Display

Model: **BVM-D20F1E, BVM-D20F1U
 BVM-D24E1WE, BVM-D24E1WU**

Subject: **PICTURE TRIMMED AT TOP
 OR LEFT EDGE**

Figure 1

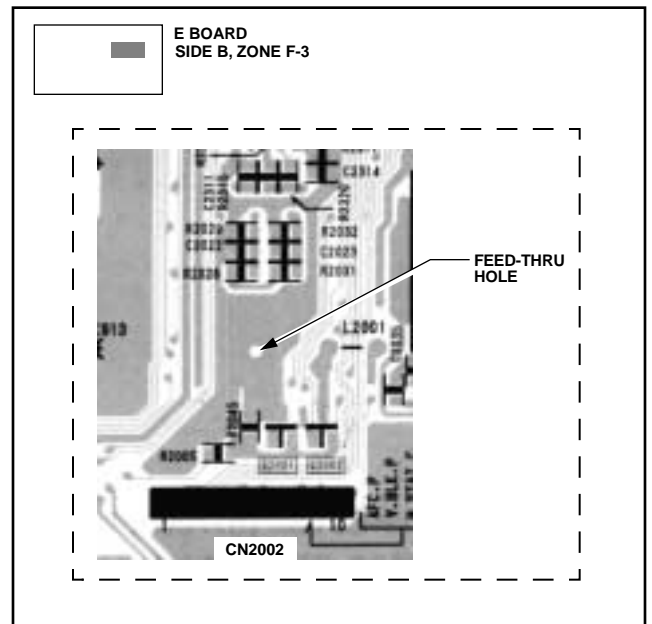
1. On IC2006, cut trace between pin 4 and GND.
 Drill feed-thru hole to cut trace between IC2006 pin 4 (side A, zone F-3) and GND (side B, zone F-3). (See Figure 1.)
2. Solder jumper between IC2006 pin 4 and -12V bus. (See Figure 2.)
